DANE COUNTY DEPT. OF PUBLIC WORKS, HIGHWAY & TRANSPORTATION

ADDENDUM

RFB NO. 320038 - ADDENDUM NO. 02

DANE COUNTY SHERIFF'S SE PRECINCT REMODEL AND ADDITION

P101

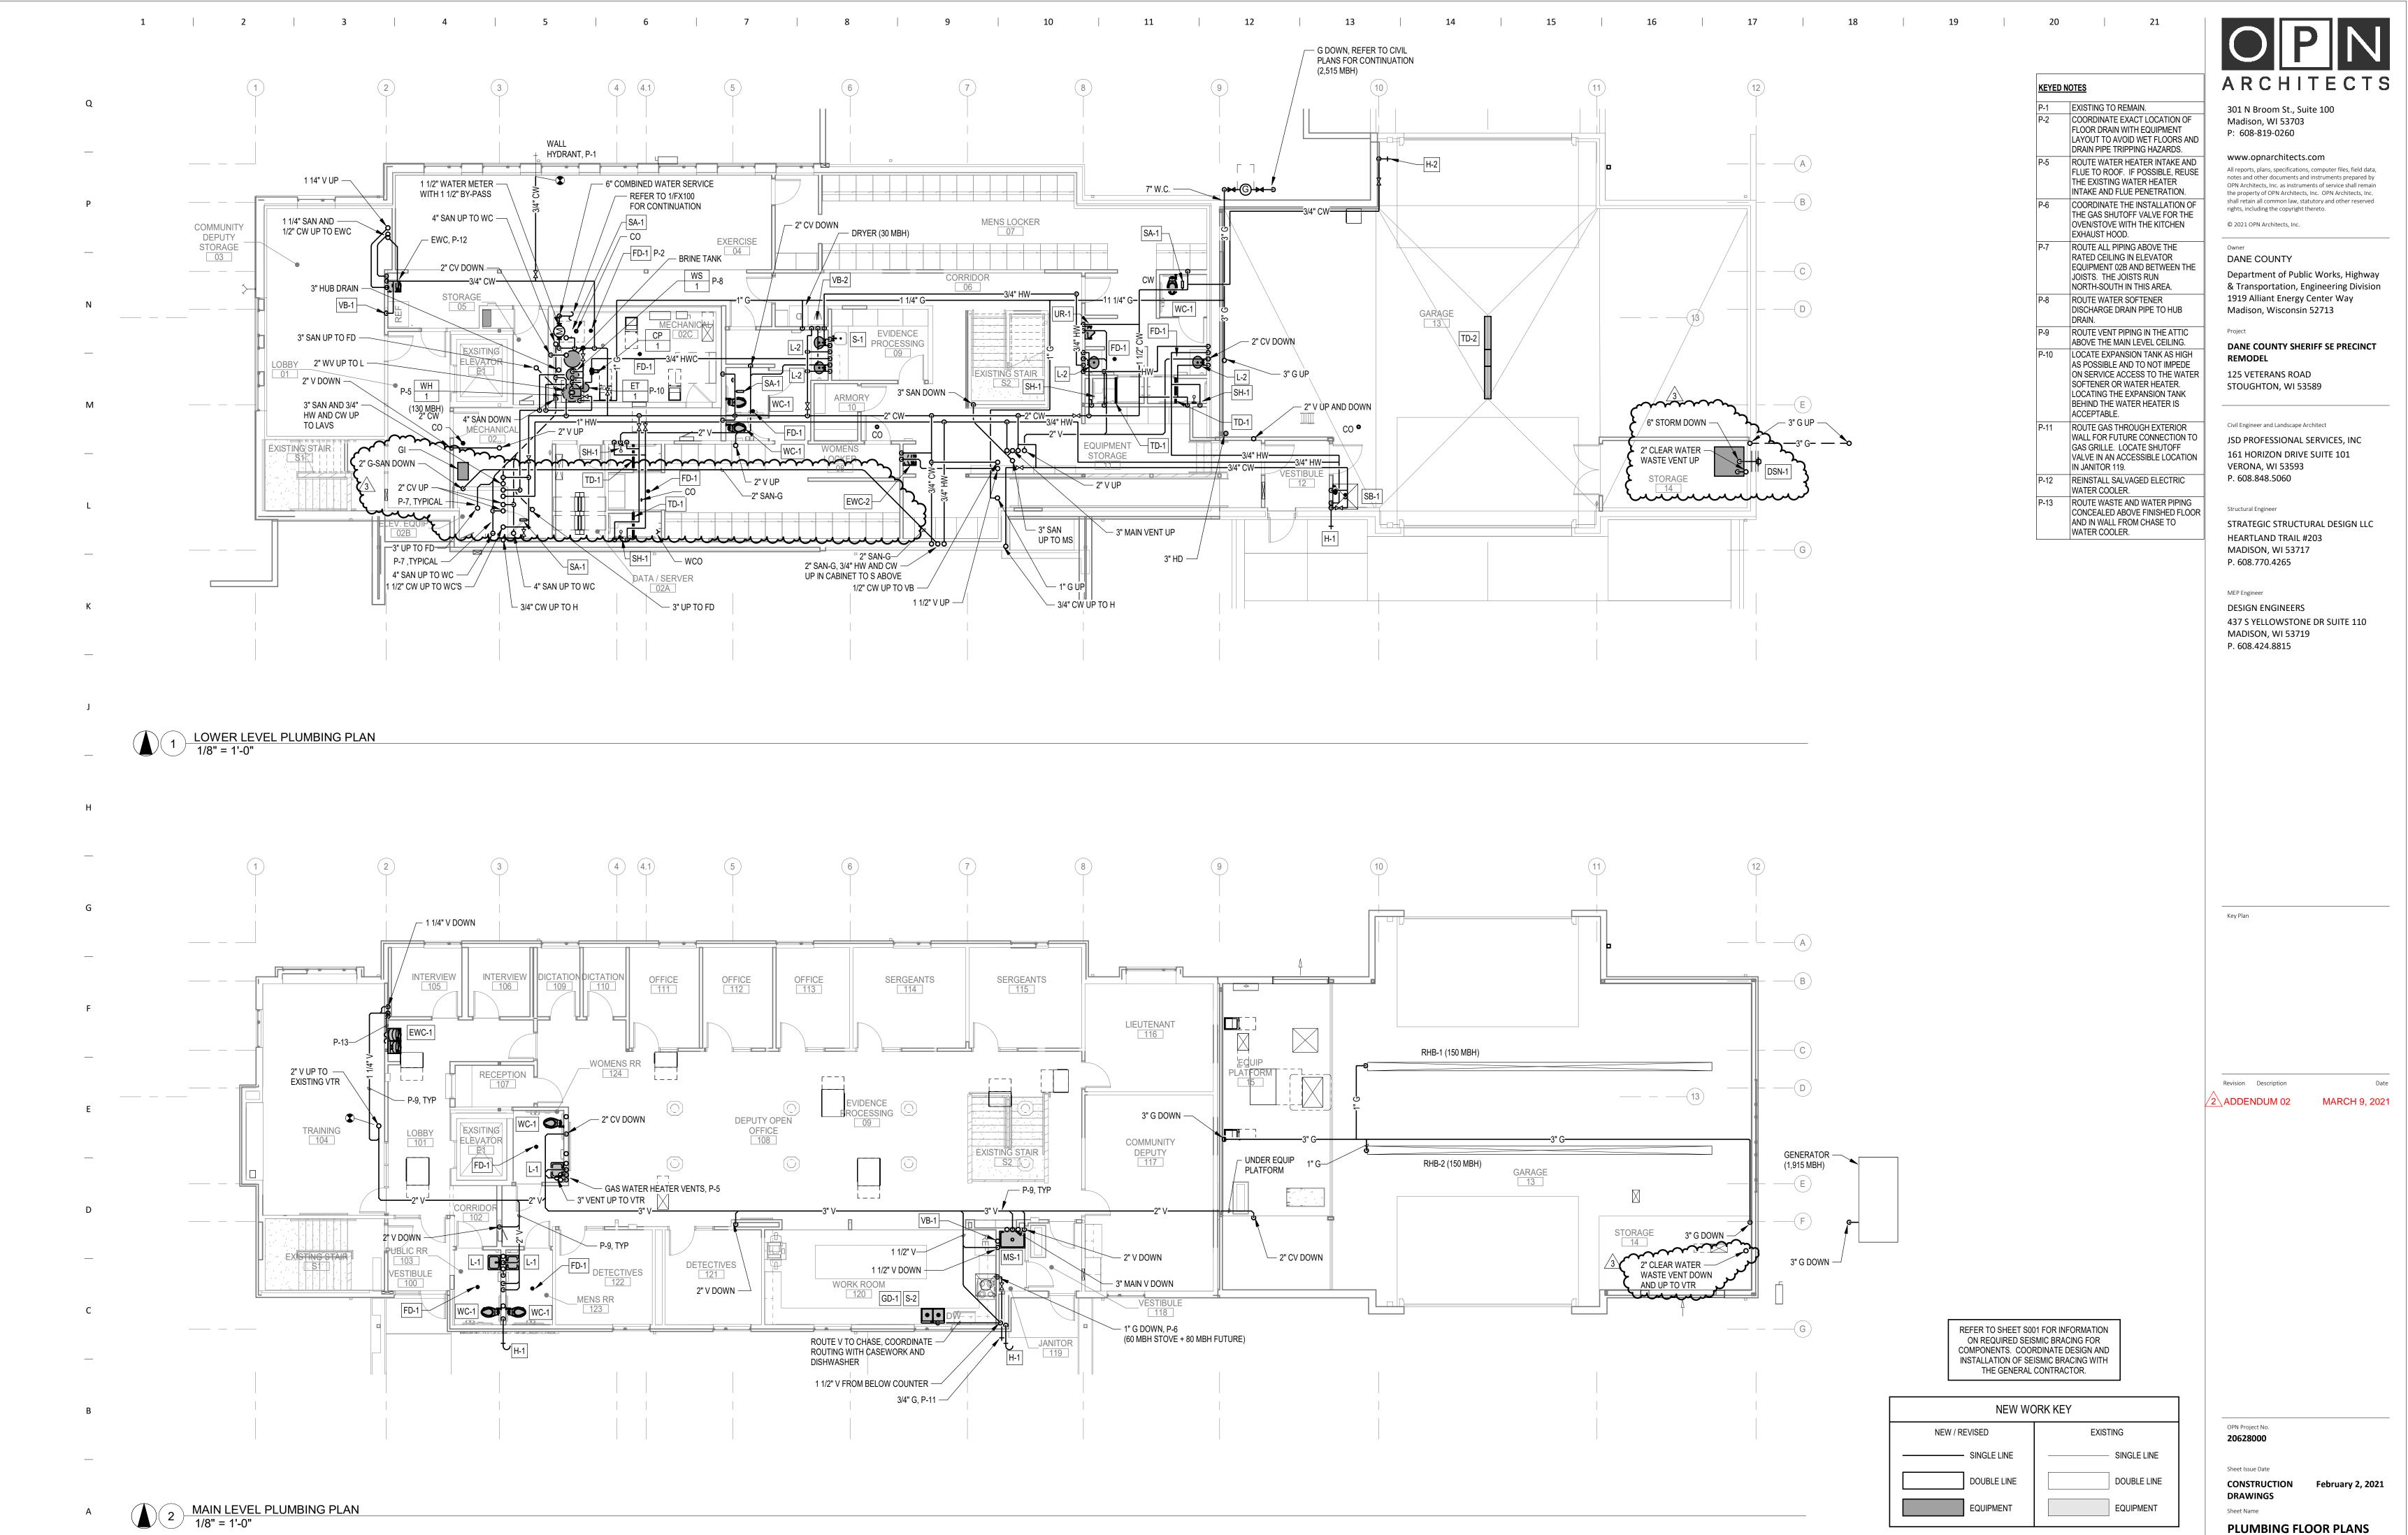
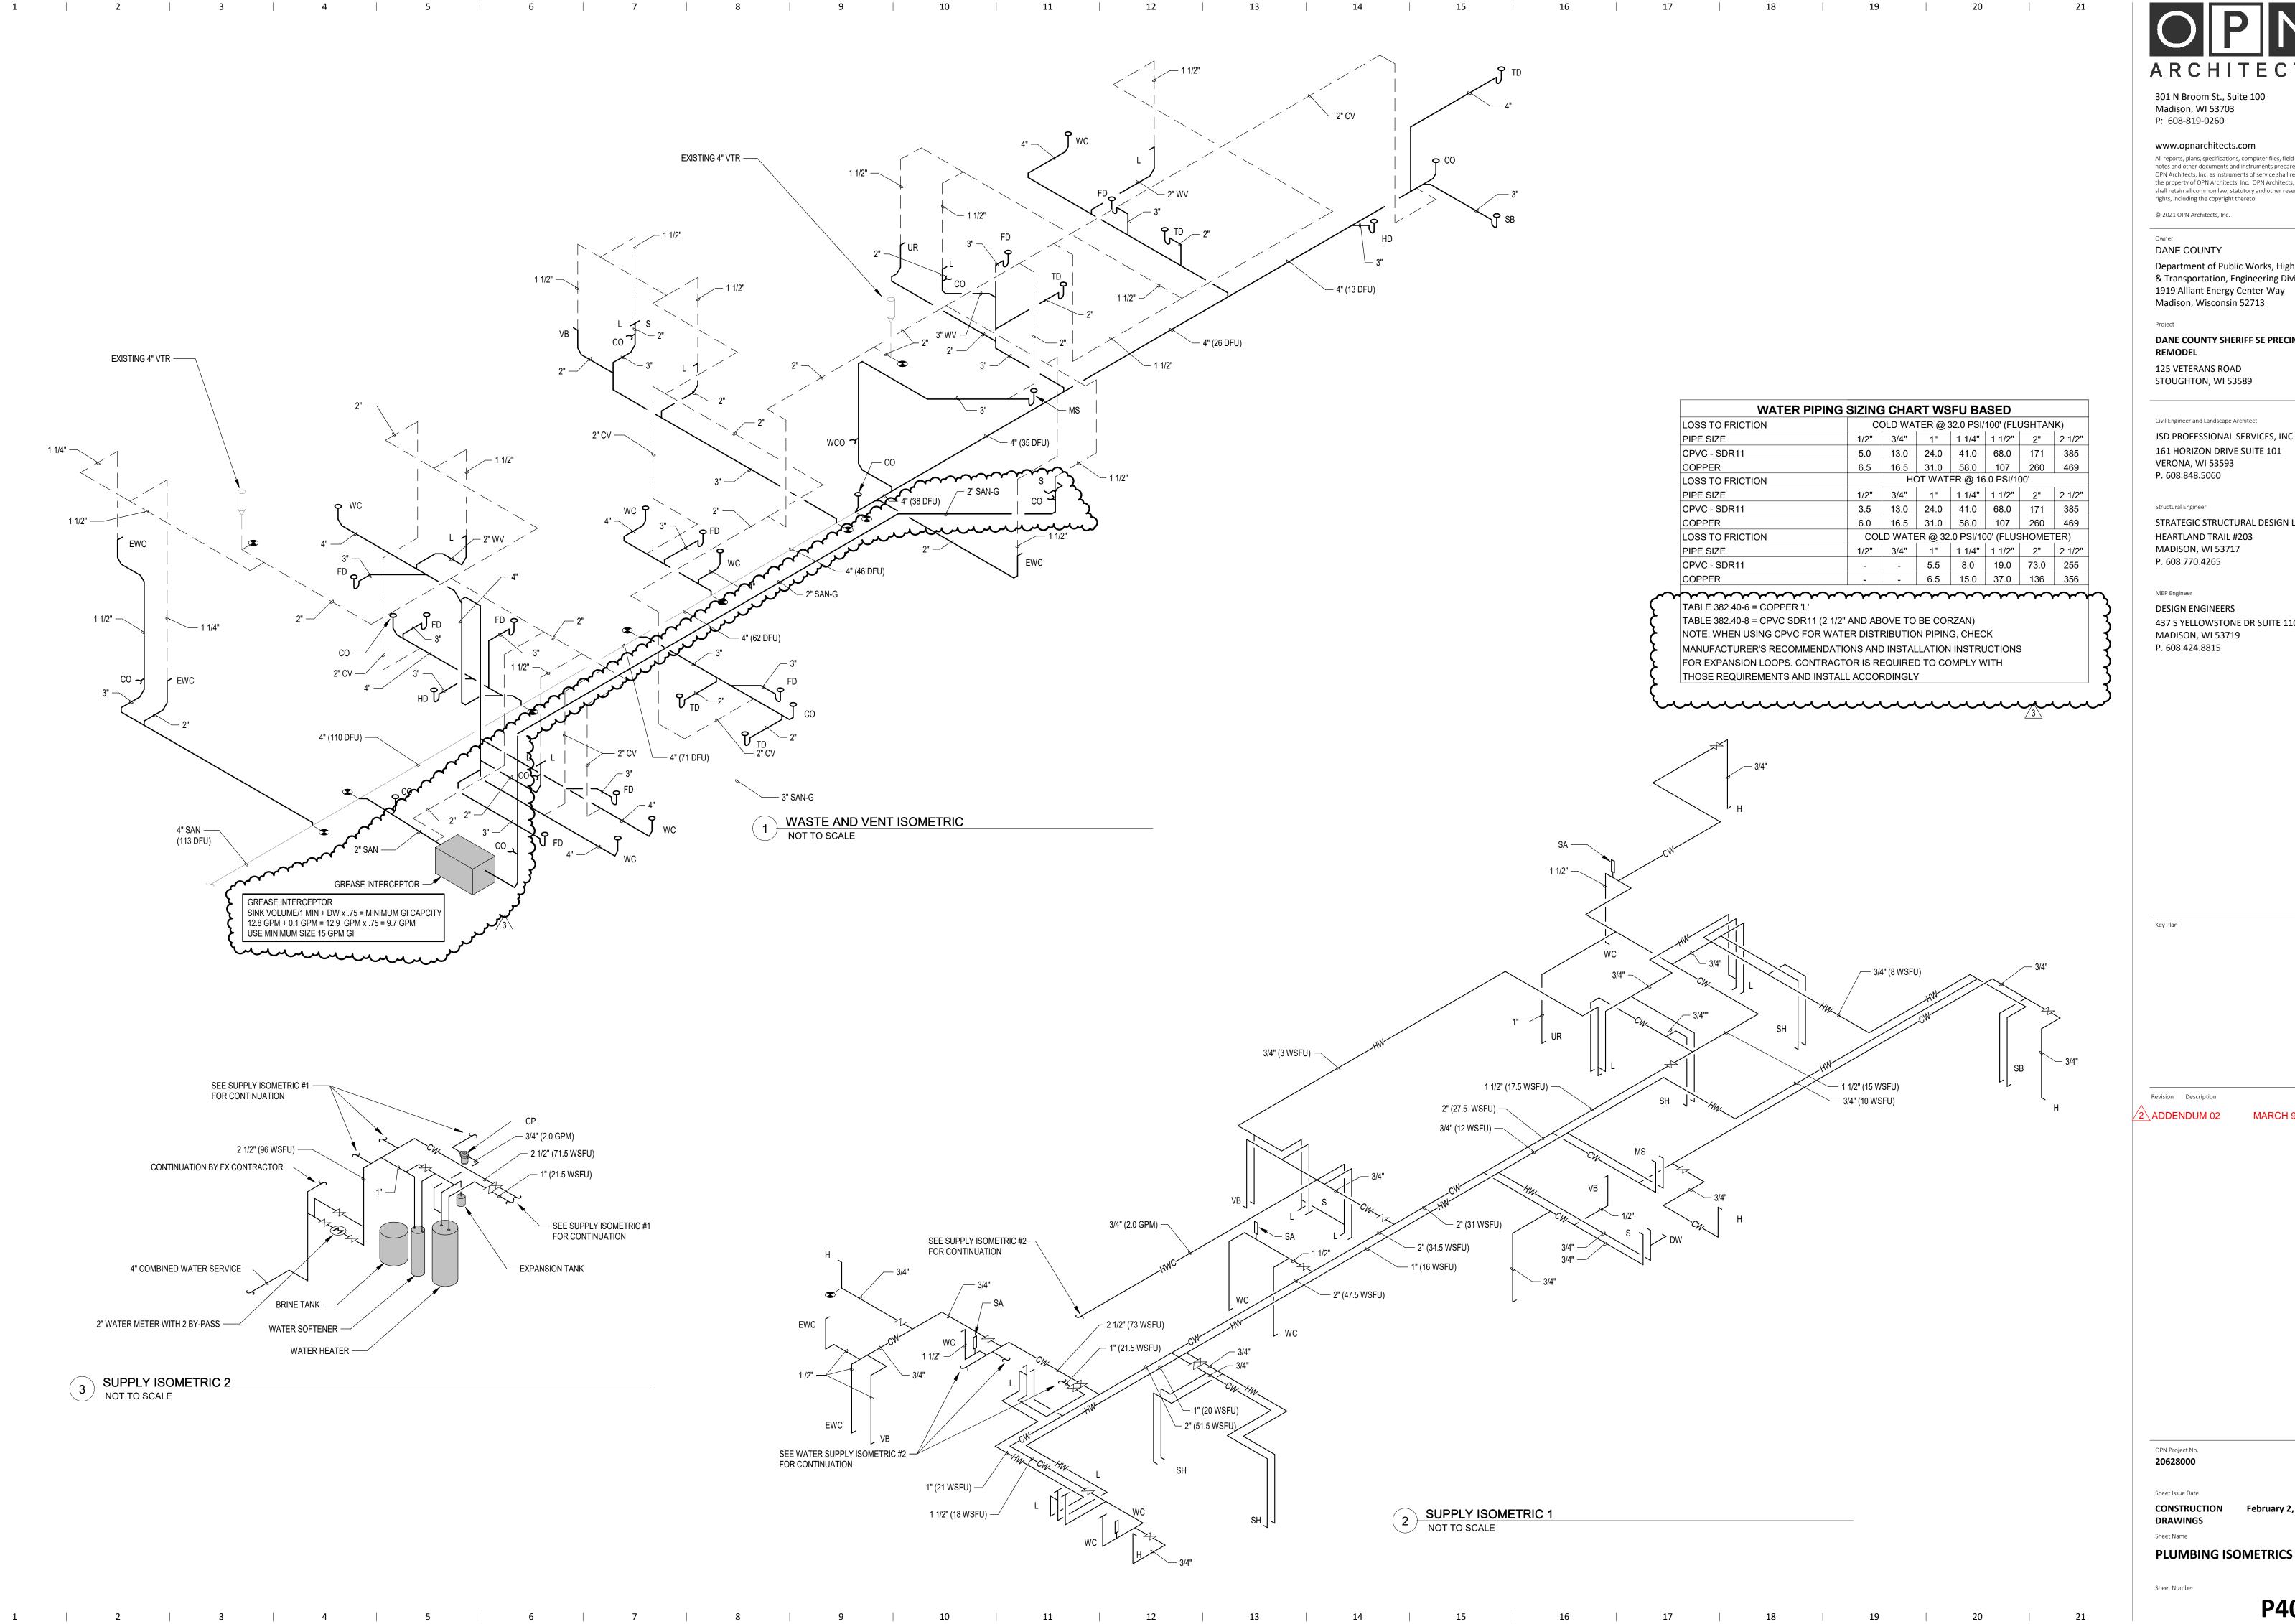
41. Sheet P101

Modify current Sheet P101 as shown on Drawing 1 as follows and issued with this Addendum:

- a. Modify to reduce the amount of sanitary waste piping upstream of the grease interceptor per request of the plumbing plan reviewer.
- b. Add storm piping and sump pump to serve trench drain shown on Civil plans and discharge above grade.
